RHODE ISLAND DEPARTMENT OF TRANSPORTATION

Bridge Group 54A -Kingston Rd Bridge

NOTICE TO PROSPECTIVE BIDDERS

ADDENDUM NO. 2 Prospective bidders and all concerned are hereby notified of the following changes in the Plans, Specifications, Proposal and Distribution of Quantities for this contract. These changes shall be incorporated in the Plans, Specifications, Proposal and Distribution of Quantities, and shall become an integral part of the Contract Documents.

RICHMOND, RHODE ISLAND

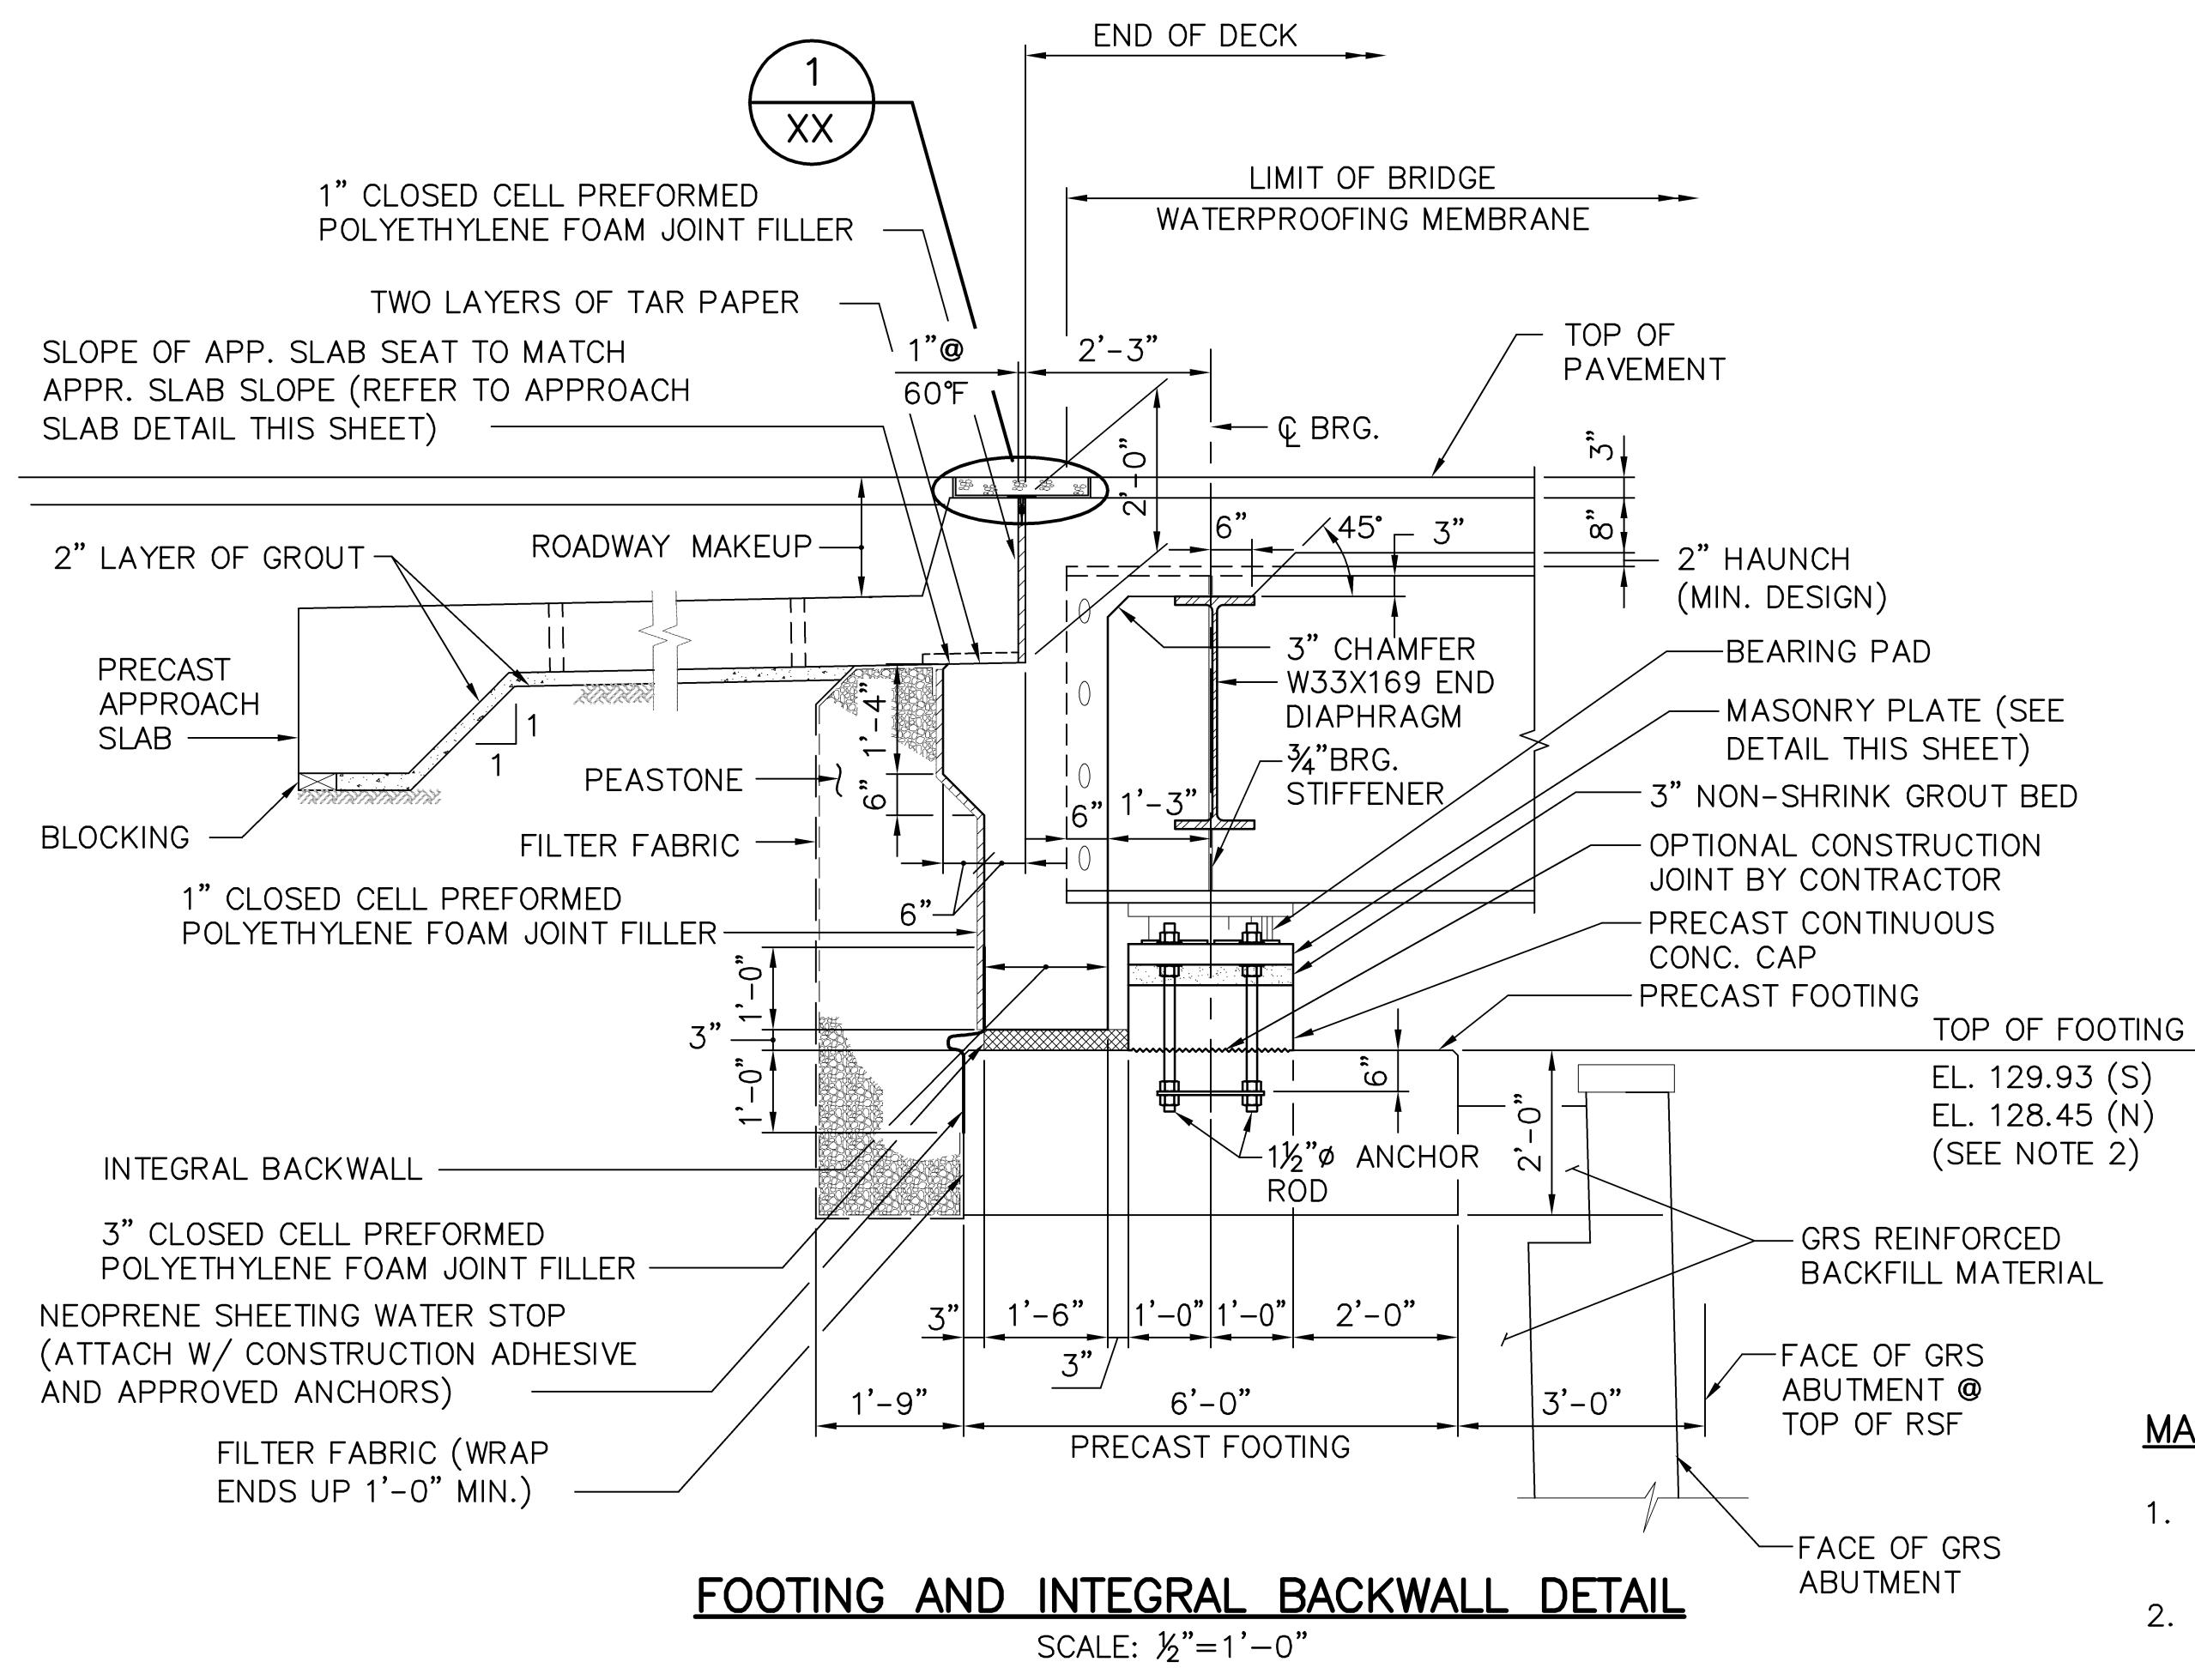
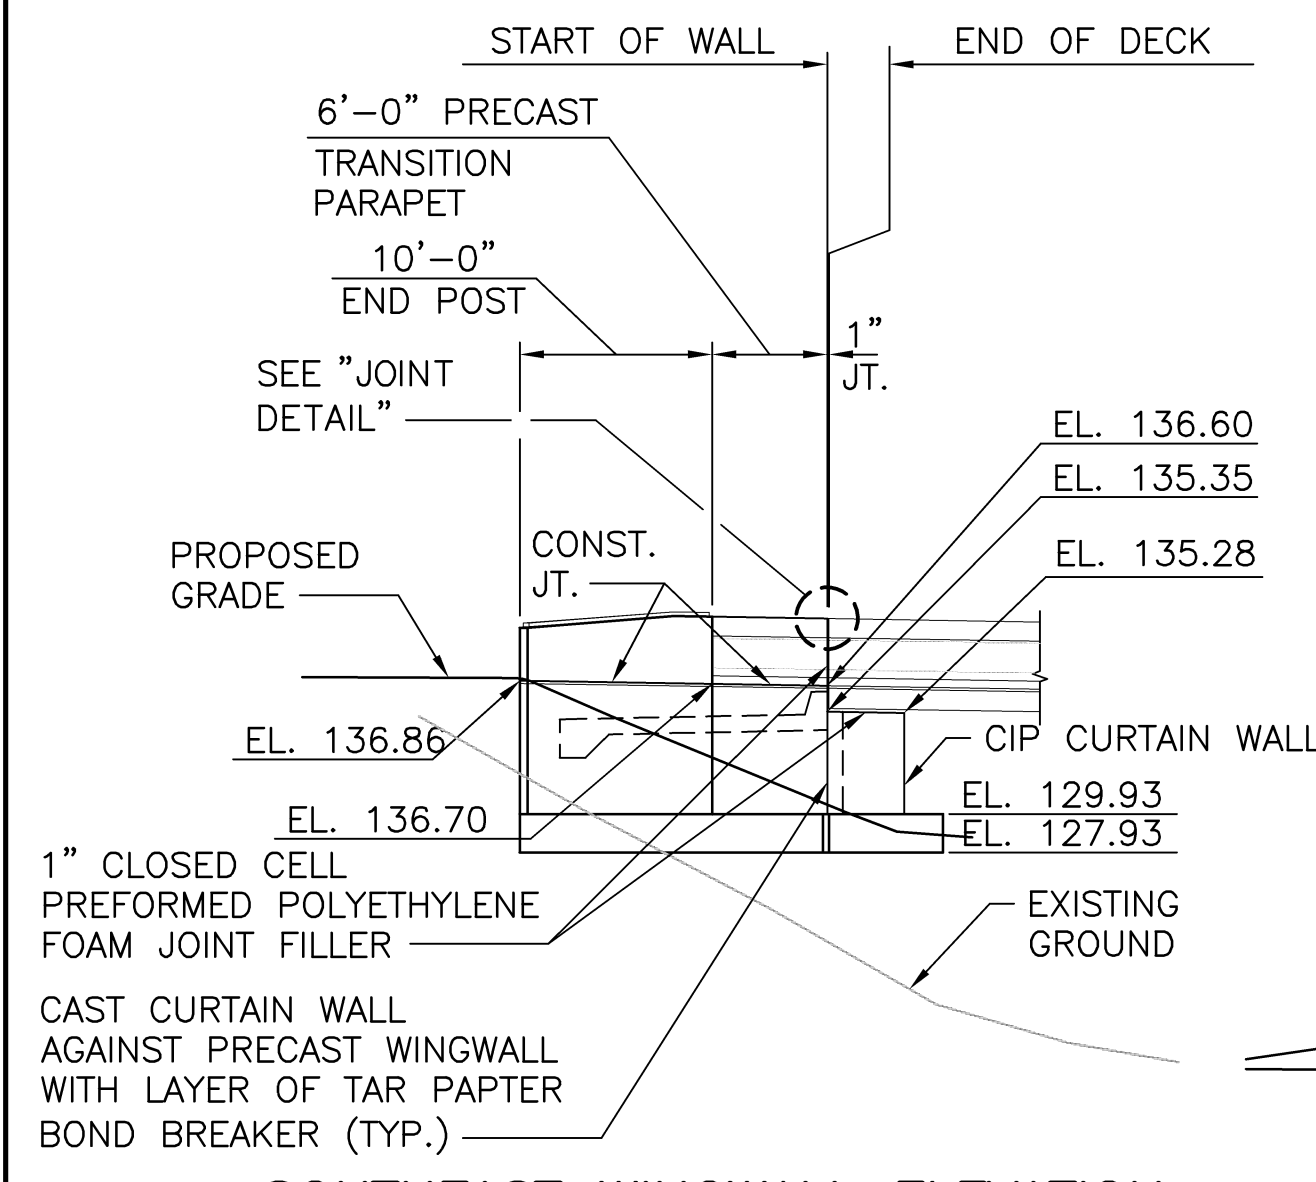
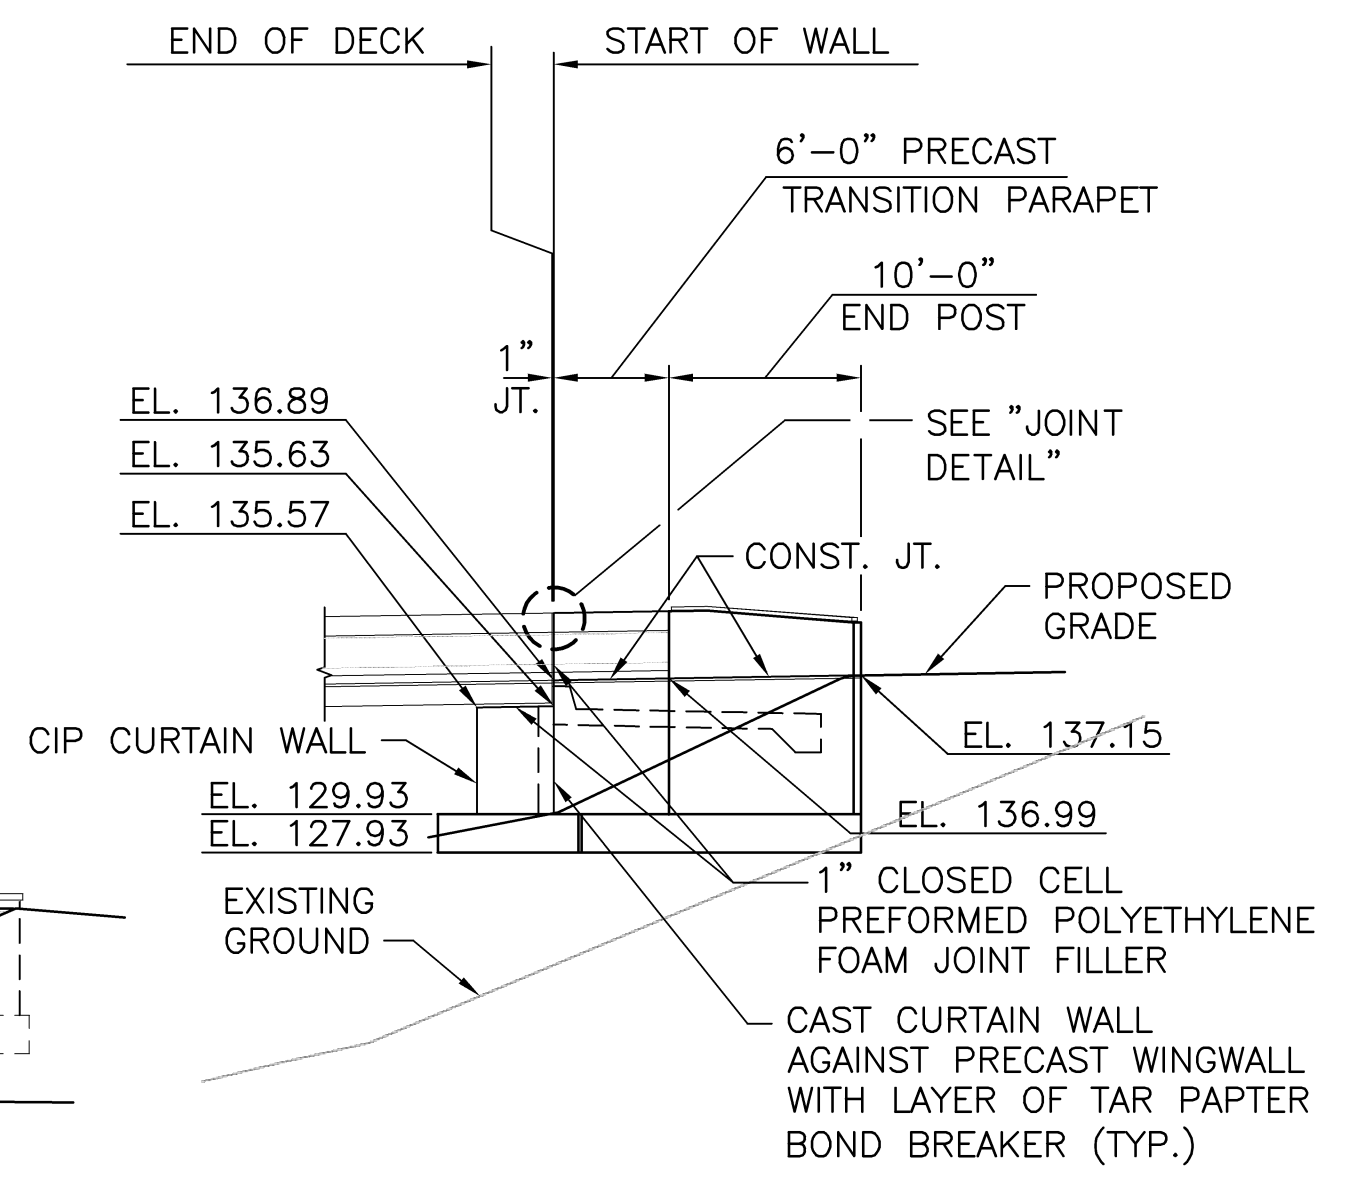
5. Volume 2 Plan Sheet No. 19 - South Abutment Plan & Elevation
Remove Volume 2 Sheet No. 19 in its entirety and replace it with revised Sheet No. 19 (R-1) attached to this Addendum No. 2. South Abutment Plan & Elevation sheet has been revised.

Please confirm-----Due to the phase line SOE , the GRS/IBS Abutments (both north and south) , once they are completed , will not be one continuous abutment , but will have a non connecting joint at the phase line.

Due to the phase line SOE, the GRS/IBS Abutments will have a non-connecting joint along the phase line. Notes and/or details will be added to the Contract Drawings by Addendum to clarify.
